Access Compliance Report Public Rights-of-Way (Curb Ramps)

Main Street: S_ROSEBAY_ST Cross Street: BROADWAY Location: SW

ADA ID: RPRK220224153442 Ramp Type: Type 3 - Combination 1 Initial Pass/Fail: Fail Overall Compliance: No Severity Score: 2

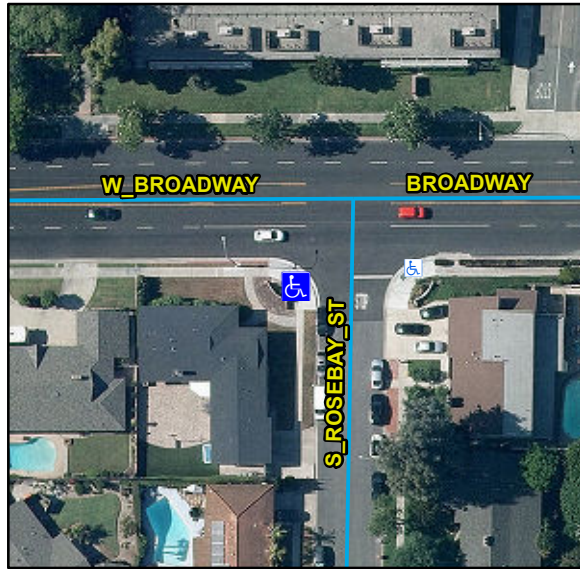
Compliance	Description	Data	Compliance	Description	Data
N/A	Ramp Length LT (in)	89	N/A	Ramp Length RT (in)	89
Yes	Ramp Width LT (in)	52	Yes	Ramp Width RT (in)	52
Yes	Ramp Run Slope LT (%)	6.7	Yes	Ramp Run Slope RT (%)	5.7
No	Ramp Cross Slope LT (%)	4.3	No	Ramp Cross Slope RT (%)	4.8
N/A	Ramp Length (in)	44	N/A	Flare Type LT	
Yes	Ramp Width (in)	48			N/A
Yes	Ramp Run Slope (%)	7.1	N/A	Flare Slope LT (%)	N/A
Yes	Ramp Cross Slope (%)	0.6	N/A	Flare Traversable LT	N/A
N/A	Landing Present	N/A	N/A	Flare Type RT	
N/A	Landing Length (in)	N/A			N/A
N/A	Landing Width (in)	N/A	N/A	Flare Slope RT (%)	N/A
N/A	Landing Run Slope (%)	N/A	N/A	Flare Traversable RT	N/A
N/A	Landing Cross Slope (%)	N/A	N/A	DWS Provided	N/A
N/A	Landing Movement Obstructed?	N/A	N/A	DWS Contrast	N/A
	Landing Movement Type	N/A	N/A	DWS Length (in)	N/A
N/A	Landing Shared	N/A	N/A	DWS Full Width	N/A
N/A	Clear Space	Yes		DWS Offset Type	N/A
N/A	Clear Space To Crosswalk (in)	N/A	N/A	DWS Offset Left (in)	N/A

Remove & Replace Curb Ramp With Two New Directional Ramps or Equivalent.
